ADDENDUM NO. 1
WATER SYSTEM IMPROVEMENTS
CONTRACT 15-01
CLARKRANGE 200,000 GALLON WATER STORAGE TANK
FENTRESS COUNTY UTILITY DISTRICT
JRWCO JOB NO. 1955

Date of Addendum: Friday, January 29, 2016
Bid Opening: Thursday, February 4, 2016, 2:00 p.m. C.S.T.

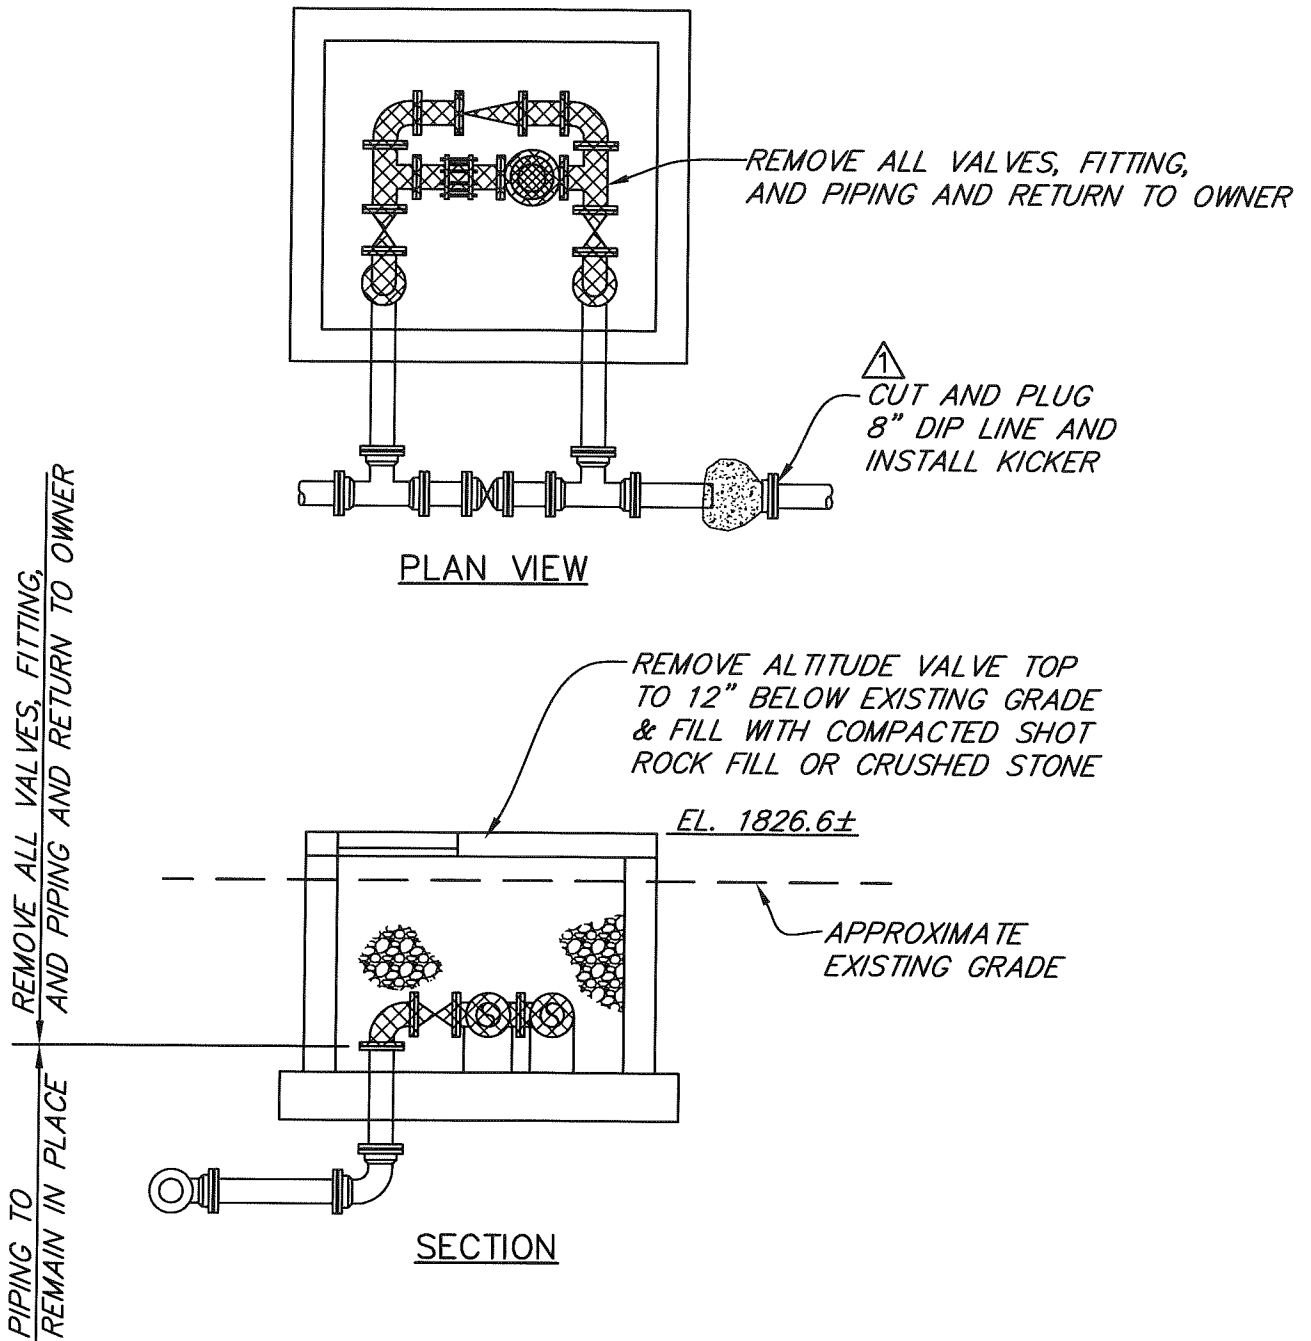
3. PLANS, Sheet 2:

Add note to “Cut and Plug 8-inch DIP Line and Install Kicker” as per the attached 8 ½” x 11” plan sheet.
